ADDENDUM NO. 2

Request for Quotation No. 9186A For Lighting at Main Sewage Pump Station

MAIN SEWAGE PUMP STATION DEMOLITION AND
SITE IMPROVEMENTS PHASE I, PROJECT 6079

**PRELIMINARY LAYOUT
TEMPORARY LIGHTING**

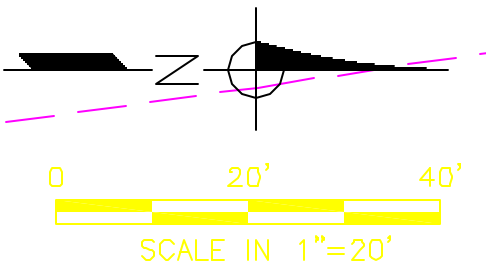
Light pole foundations: Contractor is to construct light pole foundations in accordance with attached detail showing 2 ft dia. X 5 ft deep concrete base, 2 ft exposed above finish grade, and reinforcing steel as shown. Other elements shall be in accordance with City standard drawing 442 as applicable and all poles shall be properly grounded.

PROJECT NO. 270-03-01
DRAWING NO. C1
E.P. No.
SCALE: 1"=20'
SHEET <u>1</u> OF <u> </u>

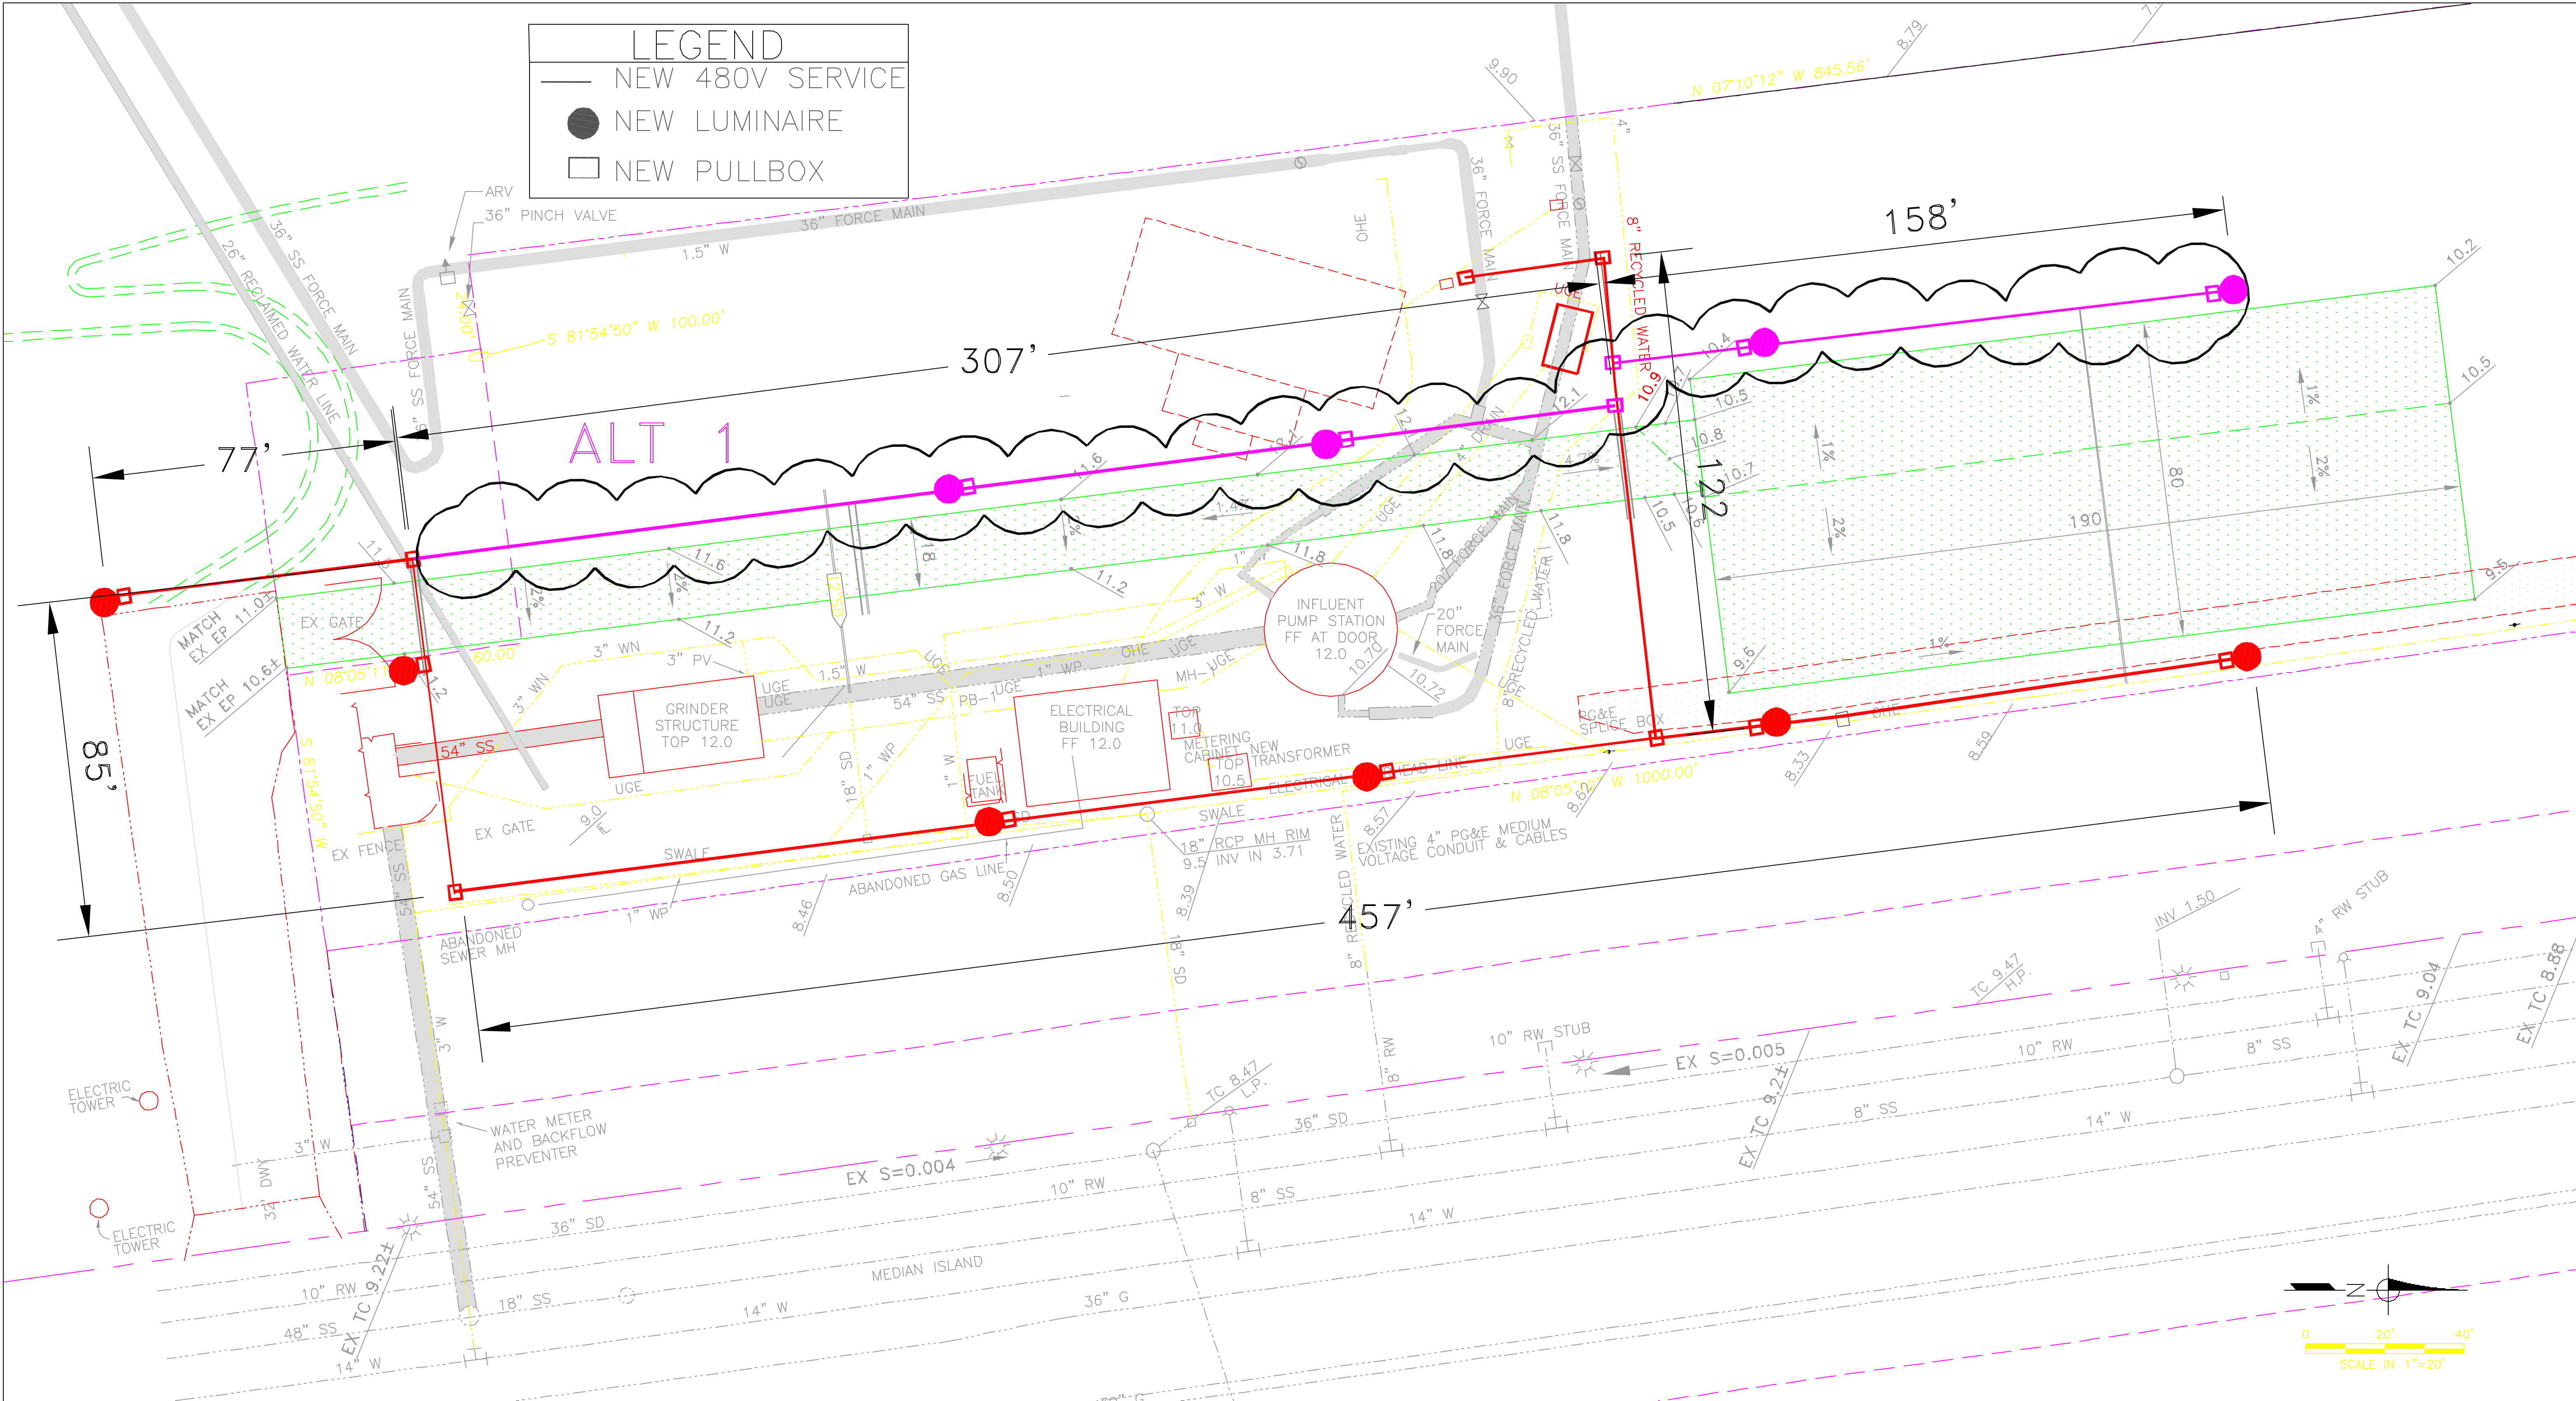
Pullboxes: quantity is increased to a minimum of ten (10); see revised layout. Additional pullboxes may be installed by contractor to facilitate installation of conduit and conductors as needed.

Layout: See revised sketch of lighting system layout dated June 20, 2005. Note that lighting system has been extended southward and eastward of original footprint. Quantity of conduit and conductor is increased accordingly. Contractor is to note the presence of existing overhead and underground utilities in close proximity to the proposed pole and conduit locations and take all proper precautions.

Protection of paving: where lighting conduit is shown to cross new asphalt driveway within the pump station, and new asphalt trail ramp, Contractor is to protect asphalt and may use available plastic sleeving at noted locations.
